22111-01-001

**Proposed Residential Development
at Mayeston, Poppintree, Co. Dublin**

ROAD SAFETY AUDIT STAGE 1 / 2

November 2022

Figure 3 Visibility splays at junction

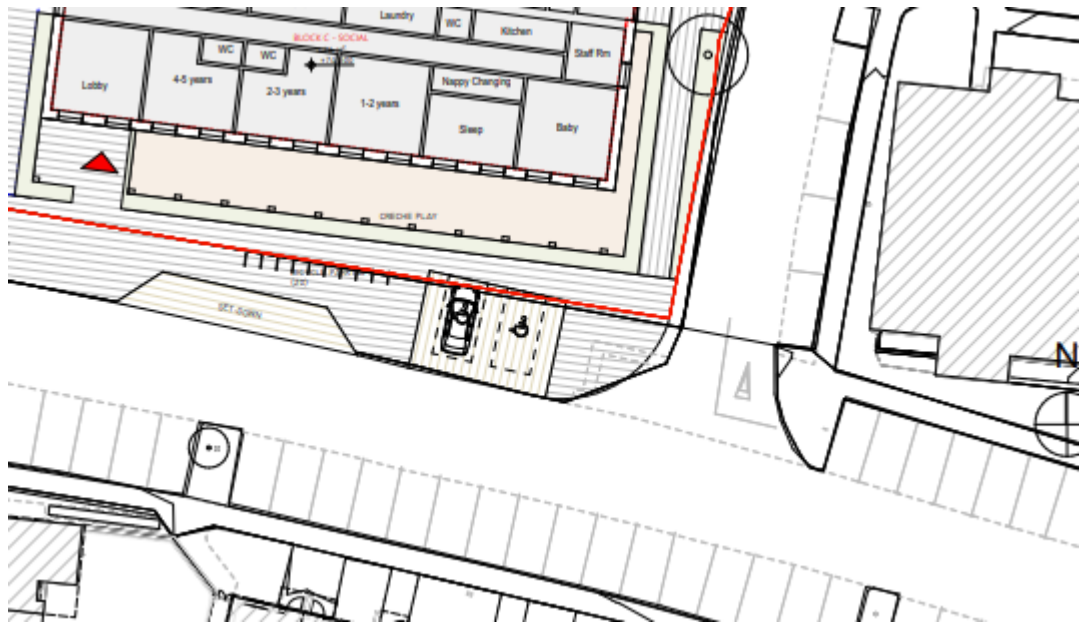
Parking spaces are proposed on Mayeston Downs adjacent to the junction with Mayeston Green. Vehicles parked in these parking spaces may restrict visibility splays at this junction. A lack of adequate visibility splays may contribute to a turning collision at this location.

Ensure that adequate visibility splays are provided at the junction of Mayeston Green with Mayeston Downs.

Figure 4 No pedestrian crossing facilities shown

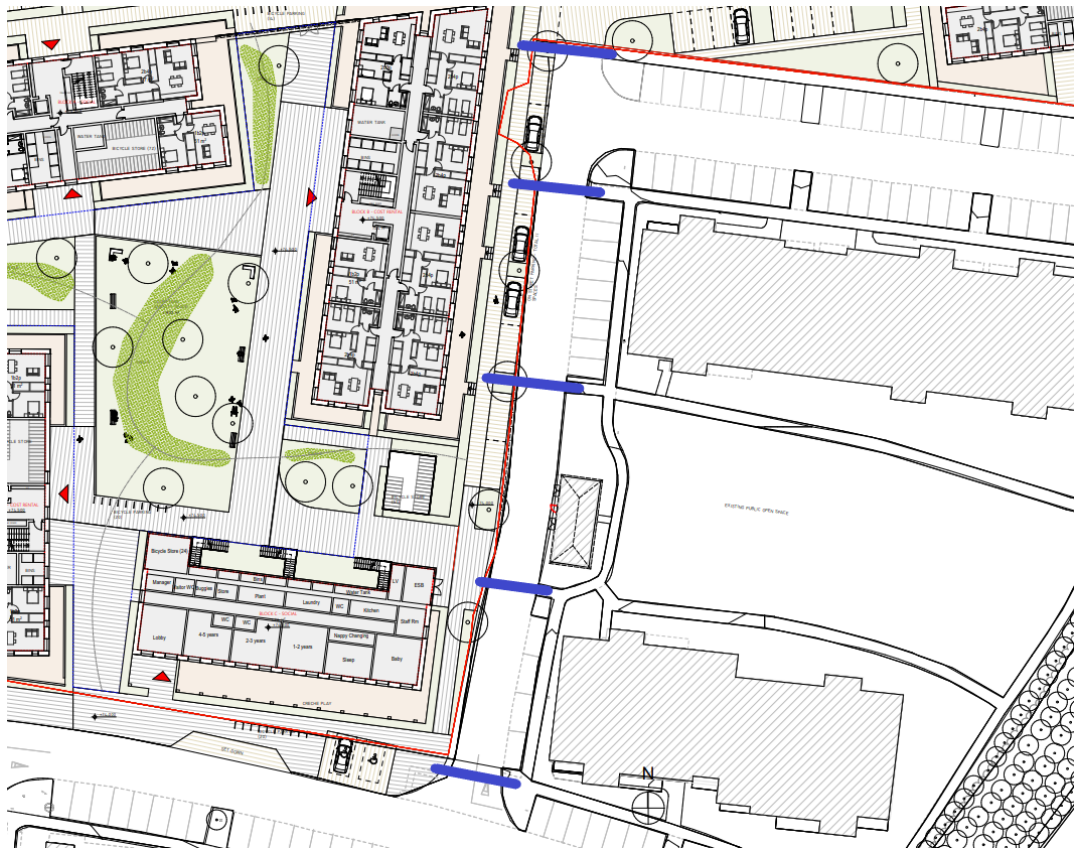
This site is on the opposite side of the road to the other developments in the area. This means that vulnerable road users will have to cross the roadway in order to leave the development.

However, there appears to be no dedicated pedestrian crossing facilities with dropped kerbs and tactile paving shown on the drawings to cater for vulnerable road users.

Residents wishing to access the creche or cross to the buildings on the east will have to walk through dedicated car parking with no pedestrian facilities shown on the drawings.

There is also no crossing facility provided at the junction of Mayeston Green with Mayeston Downs.

This could lead to risk taking by vulnerable road users, major problems for wheelchair users, and potential collisions with vehicles leading to injuries.

Ensure that tactile paving and dropped kerbs are provided at all footpath/cycleway crossing points throughout the development and ensure that continuity of footpaths is preserved so that residents do not have to walk through parked cars to cross the roadways.
